Stevie Ray's Comedy Cabaret
9801 Lyndale Avenue South, Bloomington, MN 55420

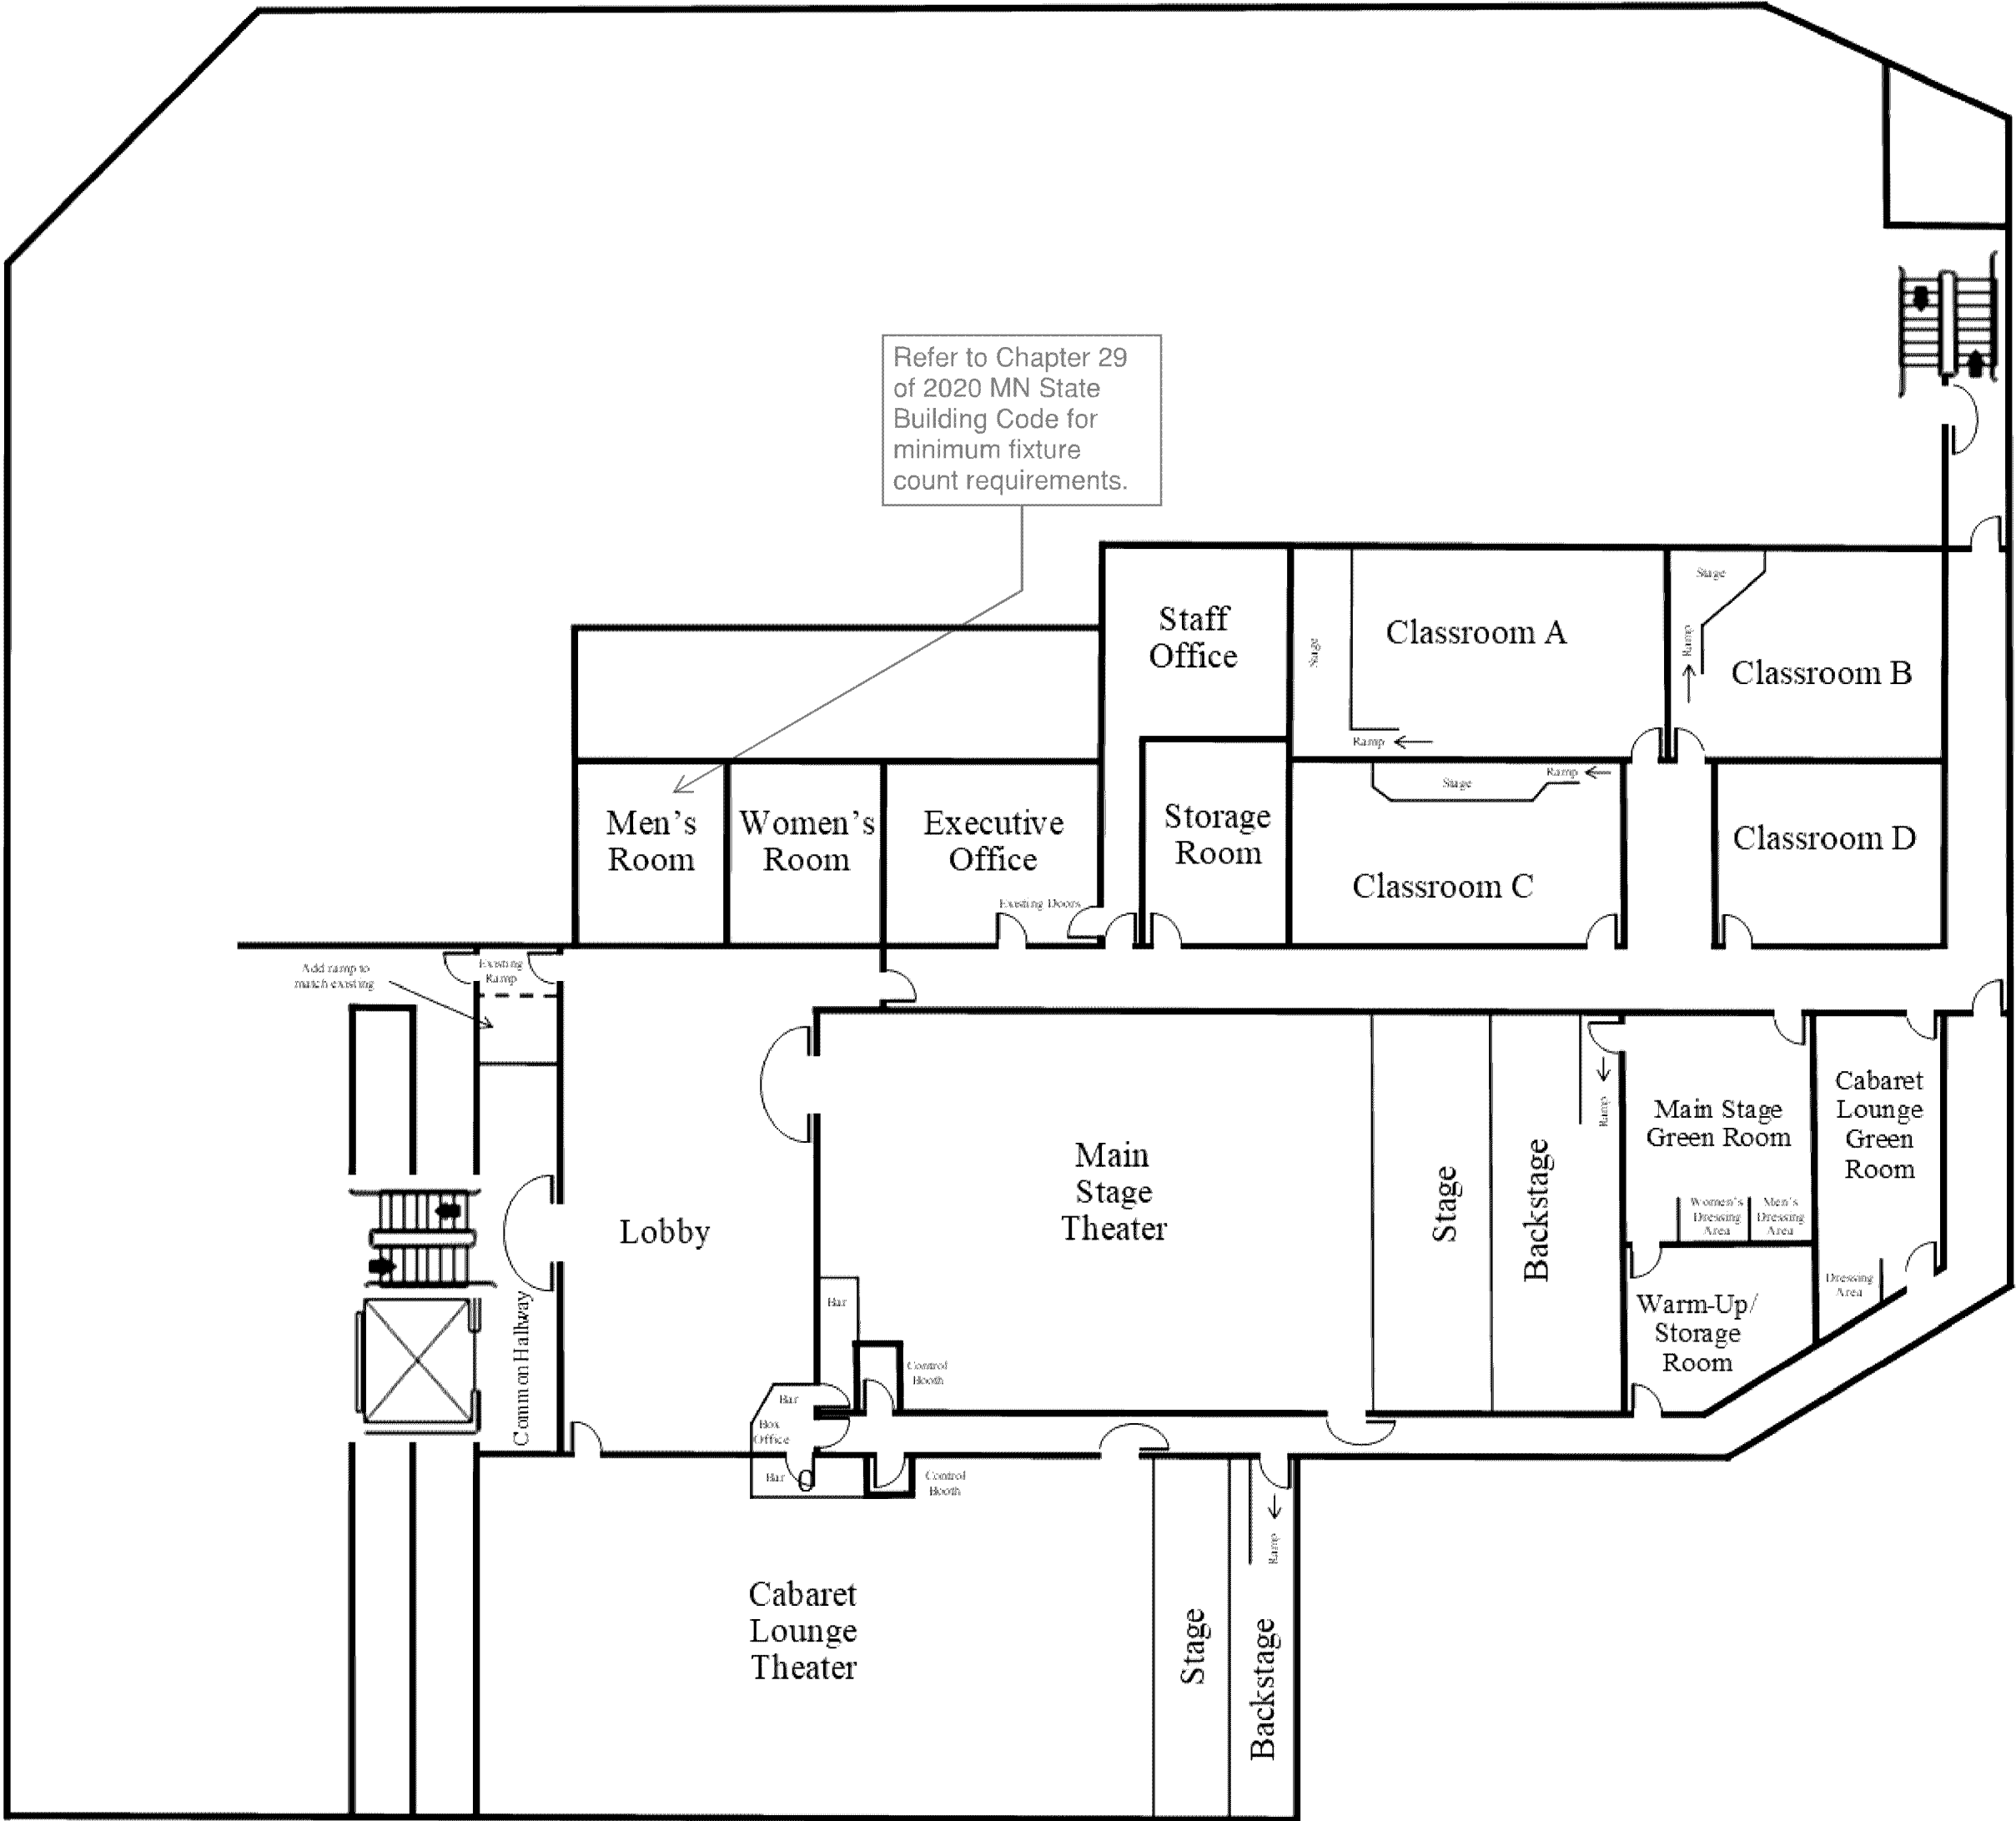
Emergency responder radio coverage meeting the requirements of appendix L in the 2015 MSFC shall be provided throughout the property and within the structures.

Fire alarm system may need to be upgrade for the assembly occupancy.

Entire space(s) must have fully Code complying sprinkler protection.

Building/property shall be adequately signed for emergency response.

Building plans must be signed by a MN licensed architect.

Must meet 2020 MN State Building Code

SAC review by MET council will be required.

Must meet 2020 MN Accessibility Code.

Provide a detailed code analysis with the plans.
